Tyler Grange Ref. 16162_R02a_Arboricultural Addendum Note_21052024_WS

Mercury 62, Knowlsey 21st May 2024

Purpose

- 1.1. This note has been prepared by Tyler Grange Group Limited (TG) on behalf of Maro Developments to accompany their planning application (Ref 22/00587/FUL) which now includes for a retaining wall on the western elevation of the proposed vehicular access point off Cronton Road. The retaining wall has been included within the proposal to reduce the amount of tree loss required to facilitate construction of the proposed vehicular access point.

Figure 2: Refined proposed tree loss (as detailed in Enclosure 3).

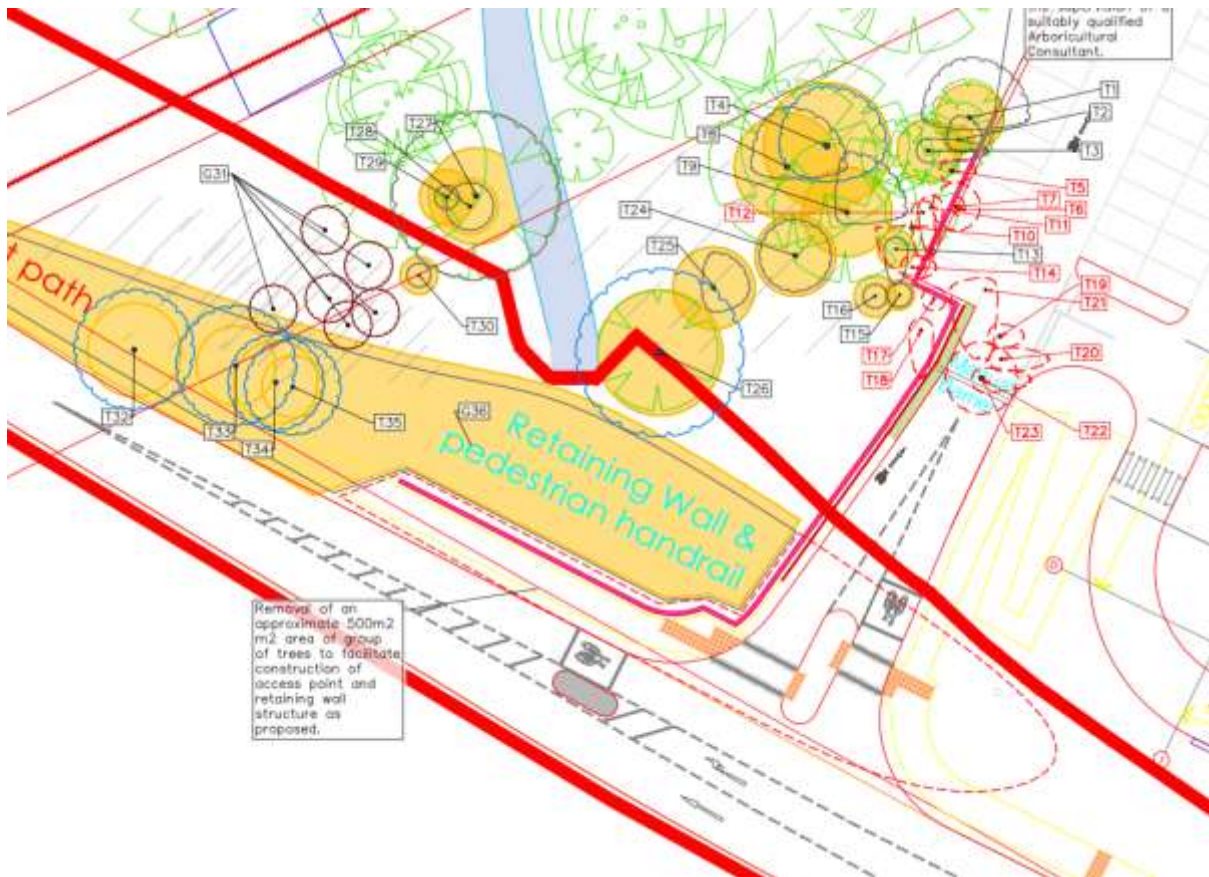
- 1.7. The refined survey data has enabled a more detailed approach to the proposed tree retention and removal. 14no. individual trees, in addition to a 500m² strip of trees are now proposed for removal. The previous survey and report did not identify nor detail the number of trees to be removed in this area. The refined survey data identified that a large portion of the previous proposed tree removals consisted of scrubby selfseeded trees, measuring less than 75mm diameter at breast height, which within the context of BS5837 do not meet the requirements to be considered a material constraint to development. As such, the survey refinements have established that there has been an overall reduction in the amount of tree removal required to facilitate construction of the retaining wall structure and access road as proposed (See Figure 2 below).

Drawing title
Tree Retention and Removal Plan

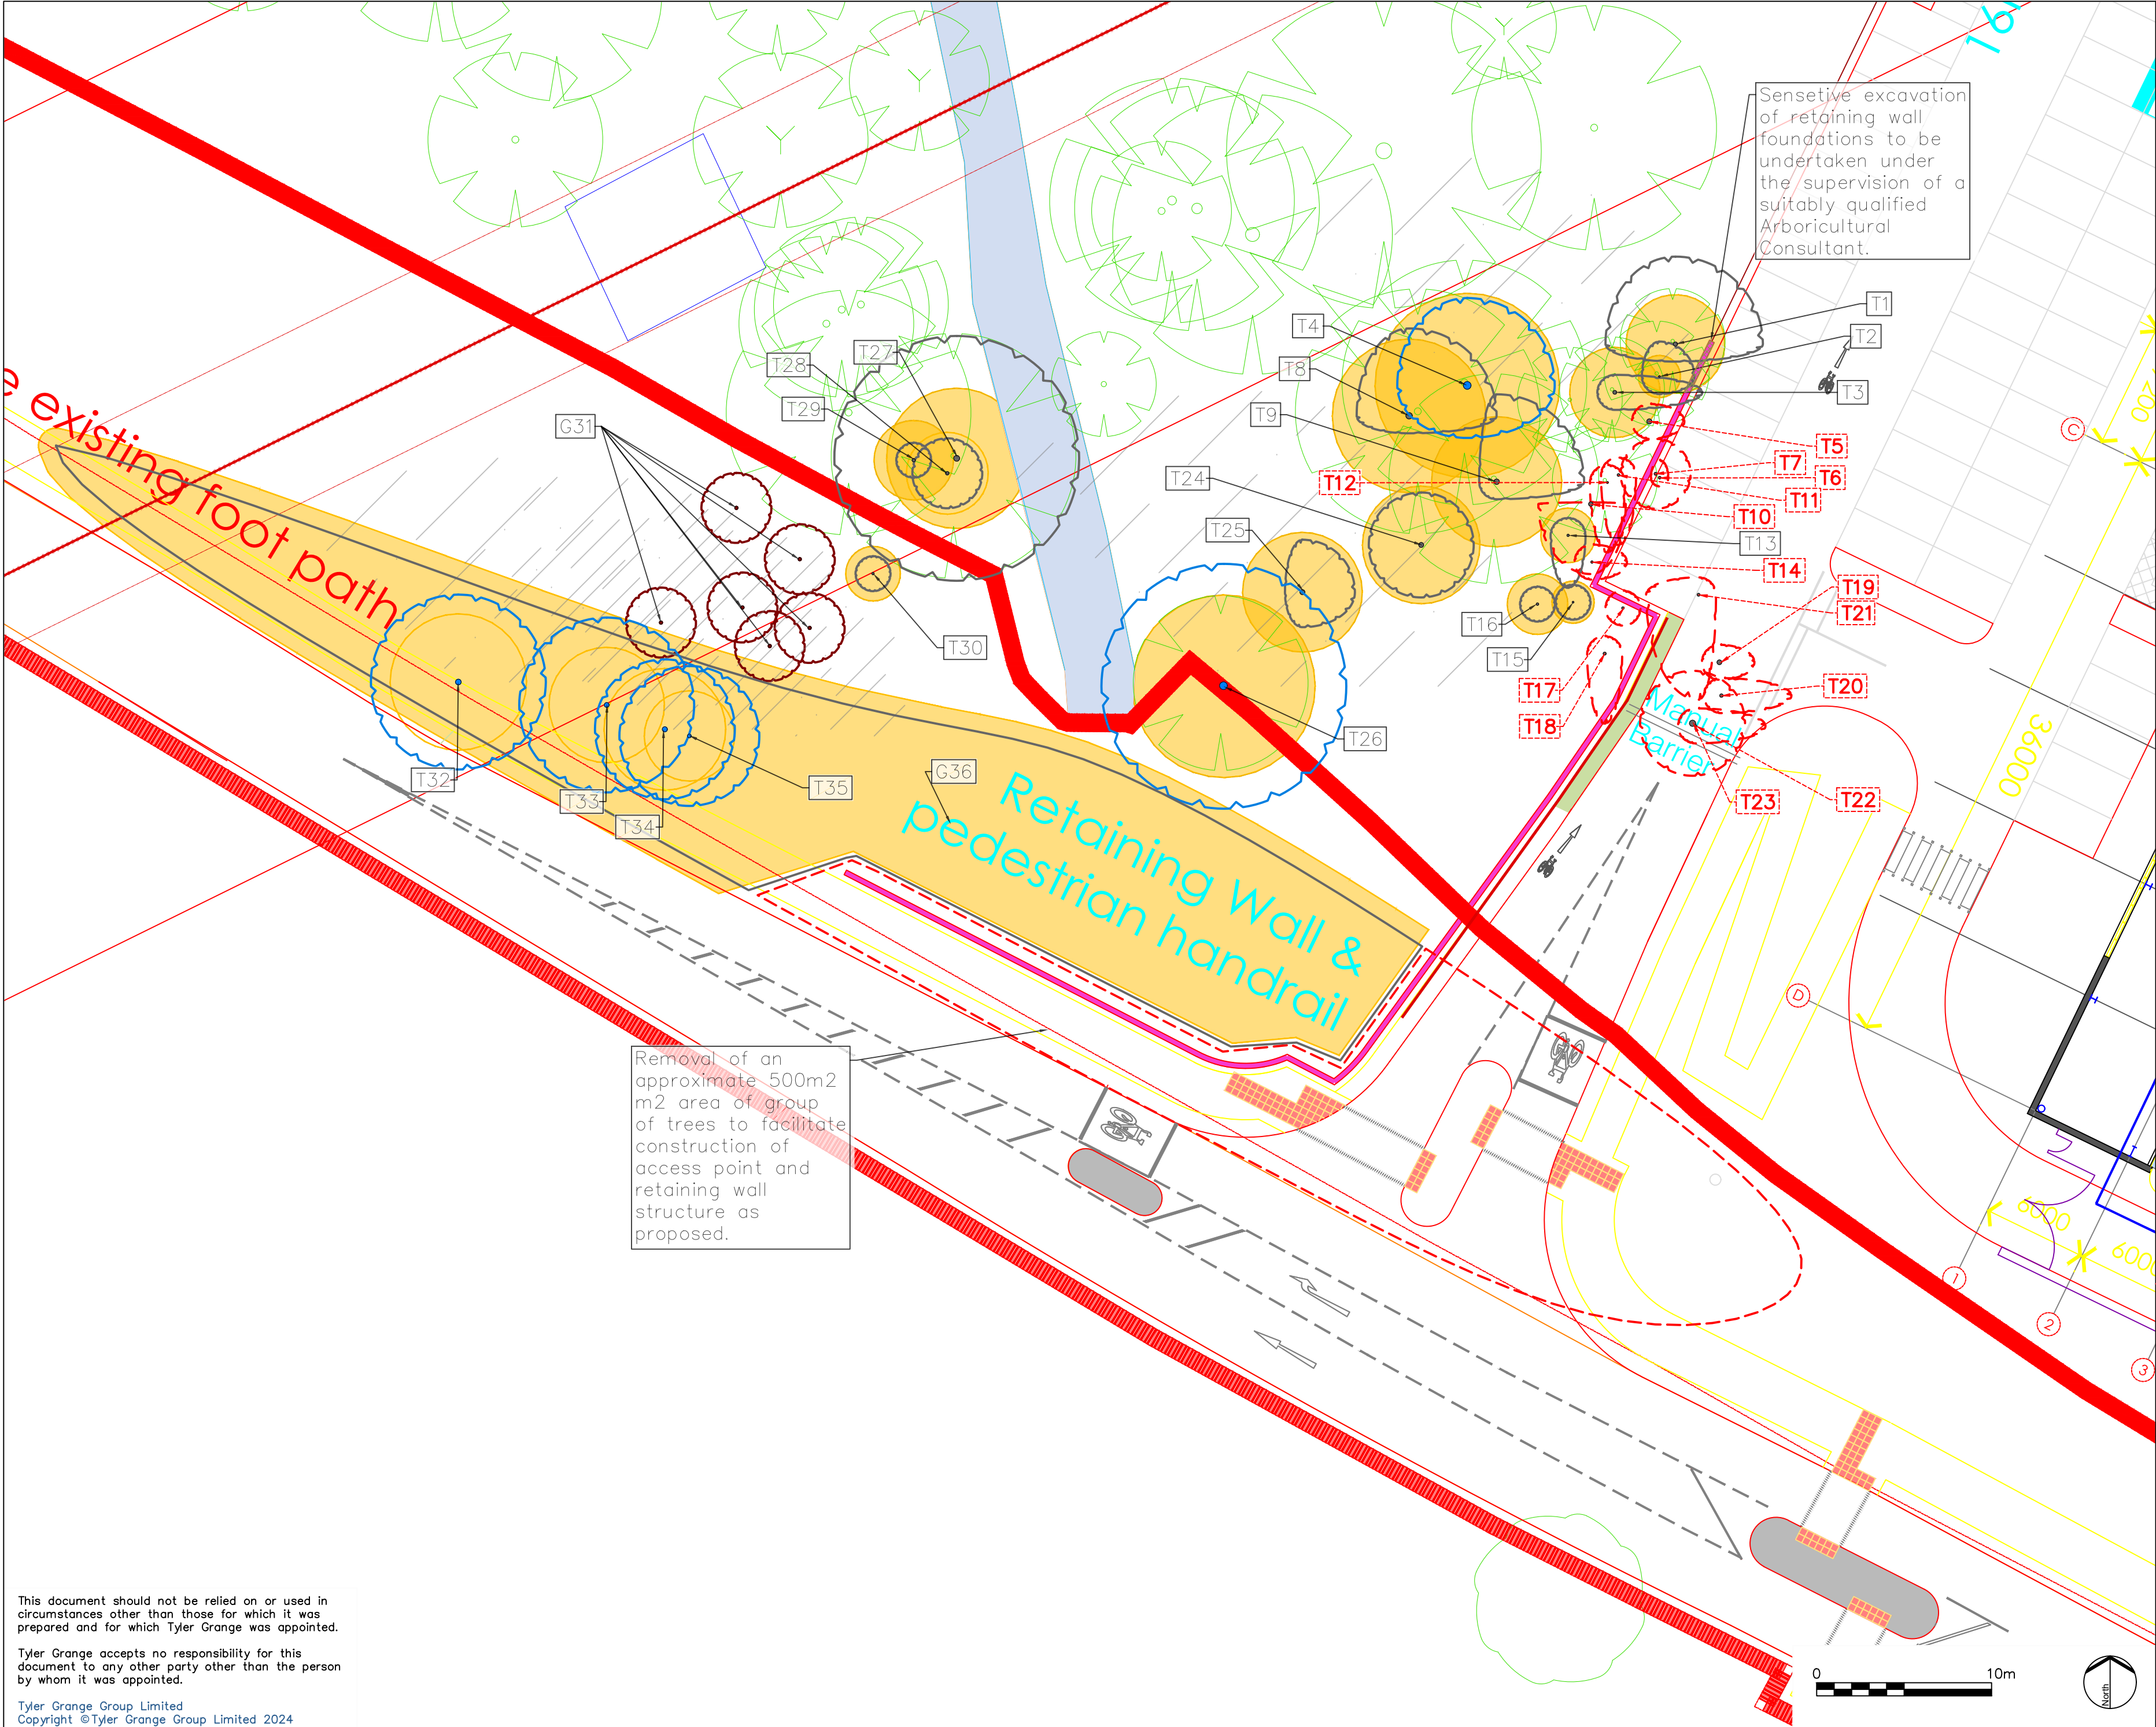
A	Tree Removal Amendments	15.05.2024
Rev	Description	Date
